# STAFF RECOMMENDATION

NCPC File No. 6713

**WASHINGTON CANAL PARK**  
Bounded by Canal, 2<sup>nd</sup>, I and M Streets, SE  
Washington, D.C.

October 26, 2006

**ACCESSIBILITY**

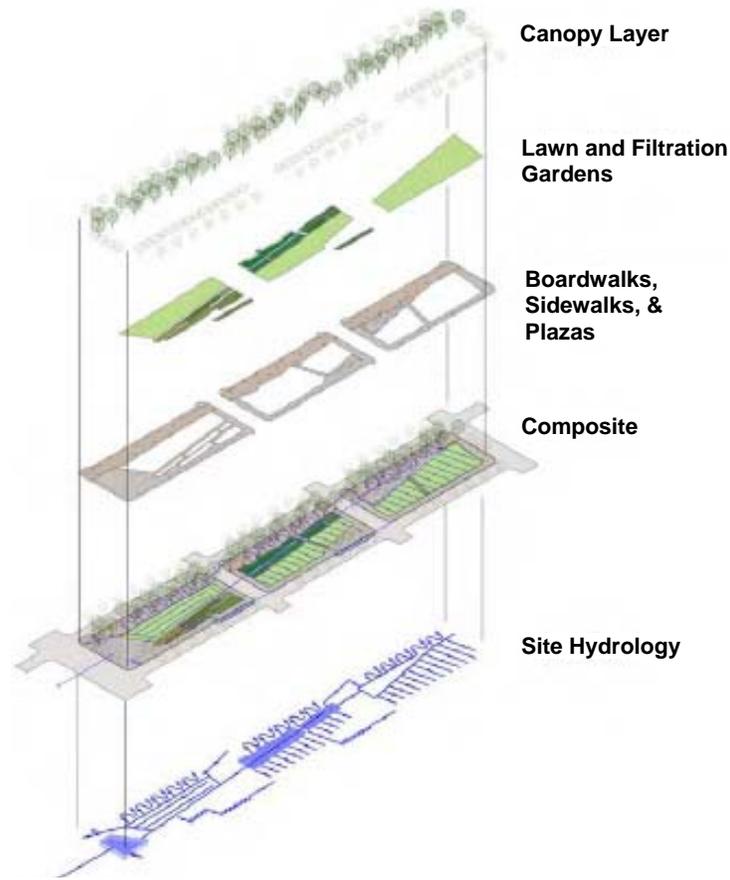
- **Accessibility** for physically disabled users should continue to be developed, including persons with visual or hearing impairments.
